Brooks Development Authority
Hangar 9 Restoration

Bid # 12072015-003
Addendum: Landscape Irrigation Requirements

Sheets L2.0 and L2.1

REFERENCE: ADDENDUM #2	SHEET # 1 OF 1	DATE: 01-18-2016
HANGER 9 HISTORICAL RESTORATION	Debra J. Dockery, Architect, P.C.	
BROOKS CITY BASE PROJECT NO. 15-01	118 BROADWAY, SUITE 516 PHONE (210) 225-6130	SAN ANTONIO, TX 78205 FAX (210) 225-7588

01 ENLARGED SITE PLAN
SCALE N.T.S.

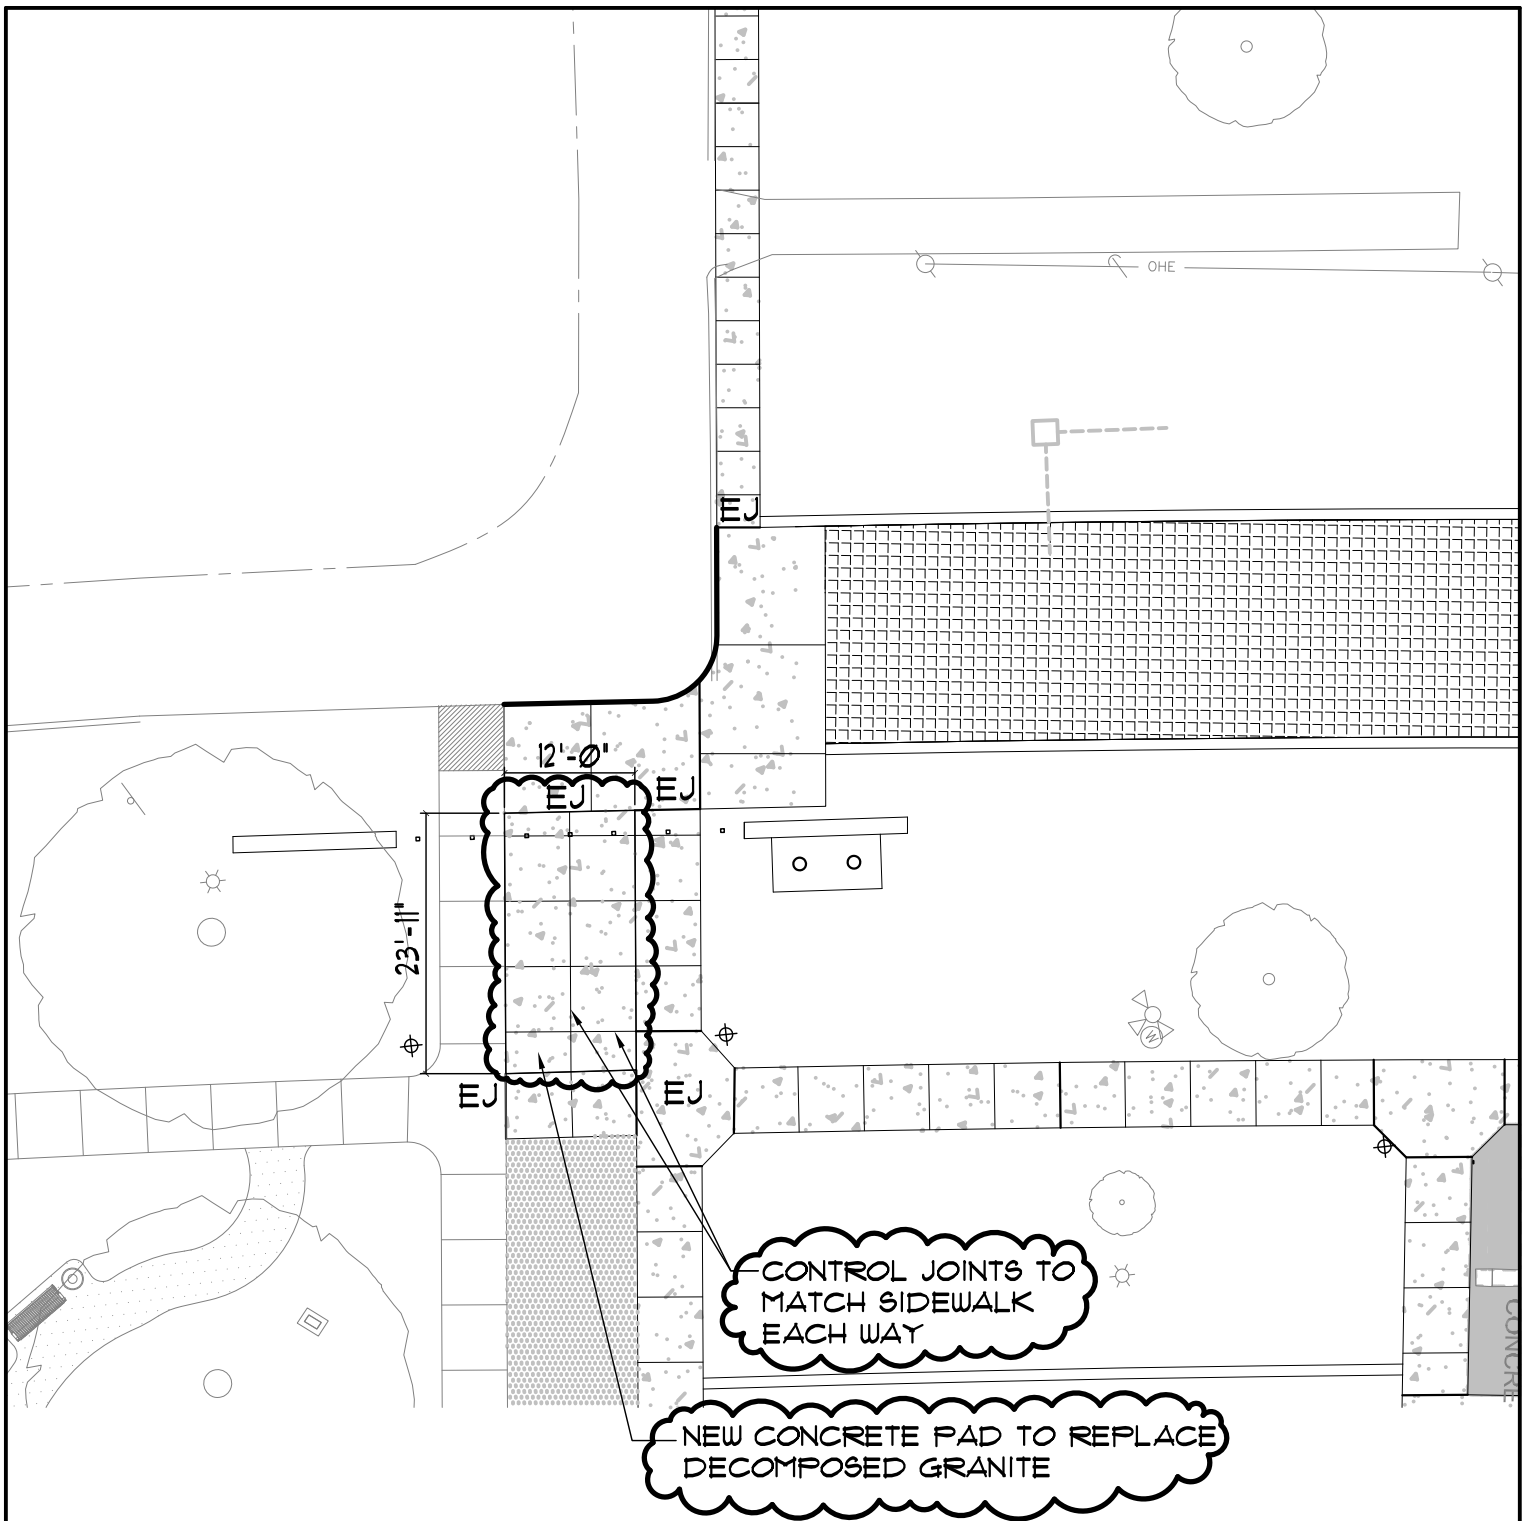
Add Central control modules to relocated Hunter ACC irrigation controllers relocated with Hangar 9 Historic Restoration project.

Install in relocated Brooks Gravesite controller Hunter ACC-COM-LAN module, and Hunter ACC/HWIM Hardware Interface Module.

Install in New Braunfels Road relocated controller Hunter ACC-COM-HWR module, and Hunter ACC/HWIM Hardware Interface Module.

Programming and connections will be made by client.

System shall be setup such that the relocated Brooks Gravesite controller functions as the primary control unit, and the New Braunfels Road relocated controller as a satellite unit (HWR module), hardwired into the Gravesite controller (LAN module).
